**South Gippsland Shire Council****Planning Delegation Report**

Planning Permit Application 2021/49 - 89 Beach Parade Sandy Point VIC 3959

<b>Application Details</b>	
<b>Application No</b>	2021/49
<b>Proposal</b>	14 lot Subdivision, Native Vegetation Removal and certification
<b>Applicant</b>	M J Reddie Surveys Pty Ltd
<b>Application lodged</b>	11 February 2021
<b>Plan Details</b>	<a href="#">D4606521</a> – Plan of Subdivision prepared by Luke Reddie Version 1
<b>Officer:</b>	Robyn Begg
<b>Property Details</b>	
<b>Property Address</b>	89 Beach Parade Sandy Point VIC 3959
<b>Land Description</b>	LA PS537365N
<b>Land Area</b>	9140m <sup>2</sup>
<b>Restrictions on title</b>	Nil
<b>Existing Use</b>	Caravan Park
<b>Planning Provisions</b>	
<b>Zone</b>	Township Zone
<b>Overlays</b>	Environmental Significance Overlay - Schedule 7 Design and Development Overlay - Schedule 3 Bushfire Management Overlay
<b>Particular Provisions</b>	Clause 52.17 – Native Vegetation Clause 53.02 – Bushfire Planning Clause 56 – Residential Subdivision
<b>General Provisions</b>	Clause 65 - Decision Guidelines

Figure 1: Proposed plan of subdivision

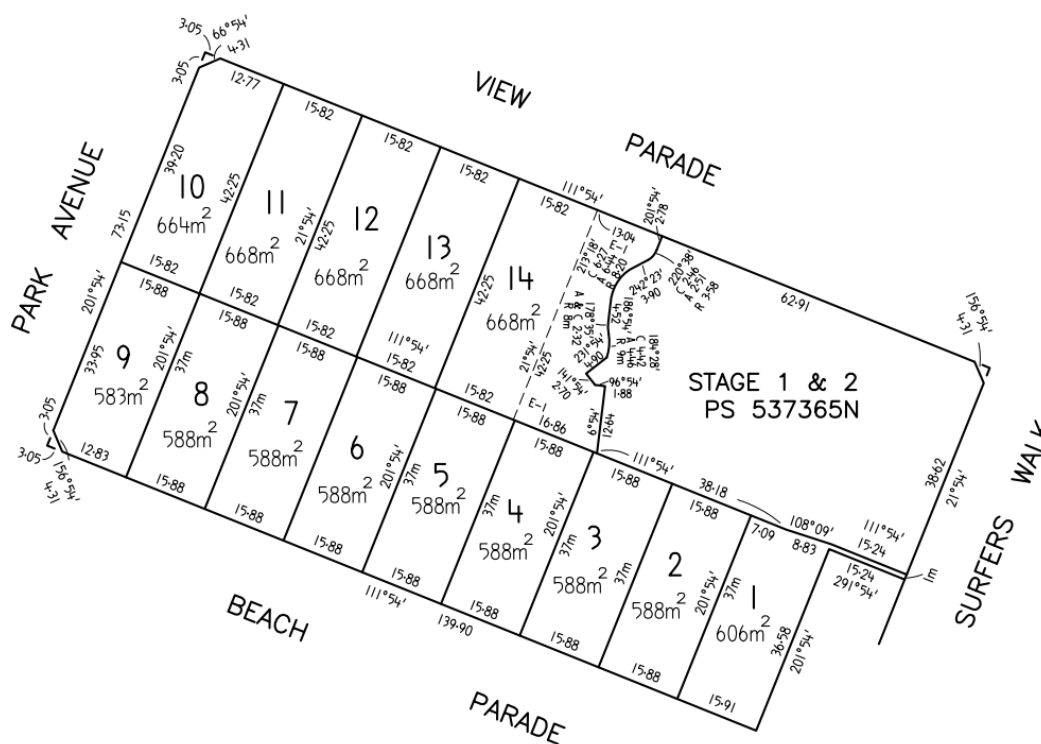
- Lots 1-13 inclusive range between 583 – 668m<sup>2</sup> with road frontages of between 12.77-15.91m.
- Lot 14 is irregular in shape and is annotated on the proposed plan of subdivision to be 688m<sup>2</sup>. The full extent of this lot is approximately 1160m<sup>2</sup> with a road frontage of approximately 20m. This lot is majority burdened by an easement for wastewater disposal

Three dwellings and five vacant lots on land adjoining to the north east are serviced by a wastewater system located on proposed lot 14, which is demarked by an easement for 'wastewater purposes'.

- Wastewater envelopes have not been identified for each lot to demonstrate the ability to accommodate wastewater generated from future dwelling development resulting from the subdivision. The Land Capability Assessment provides 'A suitable area for disposal through shallow sub-surface irrigation exists to the rear of the proposed Sub-division lots'. However, wastewater envelope size and location has not been established, and as a result it is not clear how this may affect the future development of the lots.

In the absence of detailed plans showing how waste and stormwater are to be managed, it is not possible to conclude that the proposal strikes the right balance at the density proposed. In addition, the location of wastewater infrastructure that serves a different development on land outside the subject land is not practical, nor does it result in orderly planning.

Figure 3: Proposed bushfire management plan

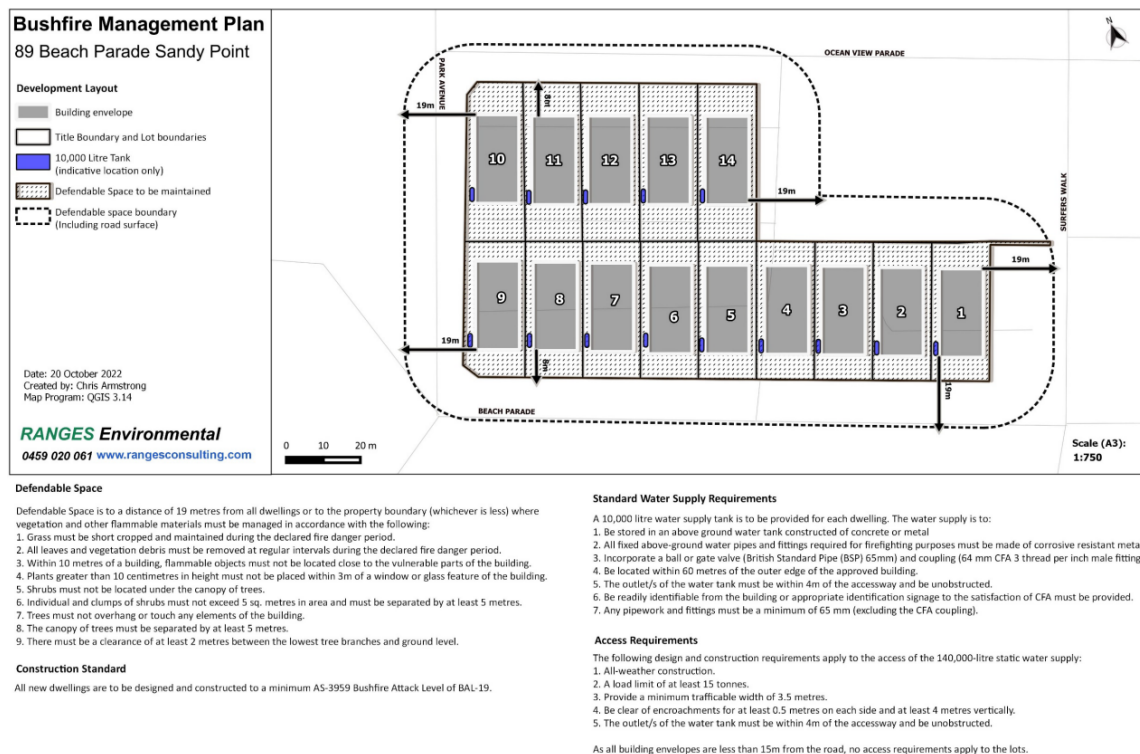
It is noted that a vegetation removal plan shows 'some' vegetation in the road reserve to be removed, but this removal alone would not meet the requirements of defensible space that 'overlaps' the road reserve/nature strip. It is observed that substantial areas of roadside vegetation would be impacted in providing and maintaining defensible space.

The proposal presents a lot yield that results in the 'transfer' of the impacts of meeting contemporary planning controls such as provision of defensible space and subsequent loss of vegetation. The bushfire provisions allow defensible space to extend outside site boundaries 'where that area of encroachment can be reasonably expected to be maintained'. An example is a road, oval or carpark, that through 'general up keep' would meet the specific defensible space maintenance criteria. The proposal shows vegetation removal in the road reserve/nature strip. However, in meeting the defensible space criteria, that includes restriction on 'clumps of vegetation to 5 m<sup>2</sup>' it is clear that the vegetation in the road reserve would need to be largely removed, and have continual pressure for roadside vegetation not removed to be maintained by future lot owners (or indeed Council). This is an unacceptable outcome given the impact on coastal character.

An overriding requirement of the Planning Scheme is to ensure protection of human life is prioritised over all other planning considerations. This does not mean encroaching bushfire mitigation measures onto public land is acceptable or appropriate. Given that the proposed solution in reducing bushfire risk to an acceptable level cannot be practically achieved, the proposal fails to meet the core premise of protecting human life.

The Bushfire Assessment provides an assessment against both the Bushfire Management Overlay and clause 52.03. Compliance with these requirements is predicated on the provision of defendable space within the external road network. Discussion of this problematic issue is provided in the Bushfire Management Overlay assessment above.

- The current design is at odds with aspects of policy relating to neighbourhood character as reflected within the Municipal Planning Strategy and Planning Policy Framework;
- The proposal does not confine defendable space within the plan of subdivision;

- There are unresolved questions as to the practical implementation of the Bushfire Management Plan and water supply requirements;
- Alternative design, or alternative approved measure to provide an opportunity to balance bushfire risk management with landscape character through a revised design response has not been provided.
